ADDENDUM

DATE: July 2, 2024 **ADD. NO.:** 3

PROJECT: Grizzly Flats Community Services District
Clearwell Replacement Project

Figure 1

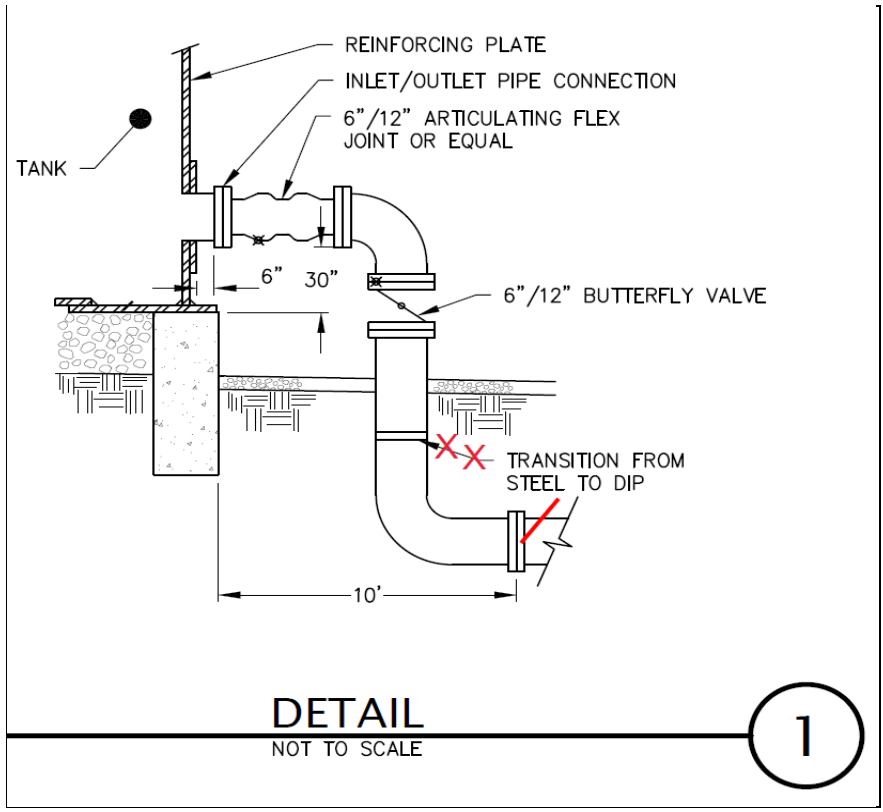
- Sheet C2, Detail 1 - The 10' dimension references the transition from steel pipe to ductile iron. See Figure 1.
- Sheet C2, Detail 5 – Drain pipe extends to new DI at existing 10" SD, as shown on Sheet C4. Drain DI to be 3' x 3' with galvanized grate. See Figure 2. DI at existing SD to be 2' x 2' with galvanized grate.
- The small steel backwash tank needs to be relocated on site. No existing concrete foundation removal required.
- Additional detail for altitude valve vault per Figure 3.
- Restrain cut-in pipe connections.
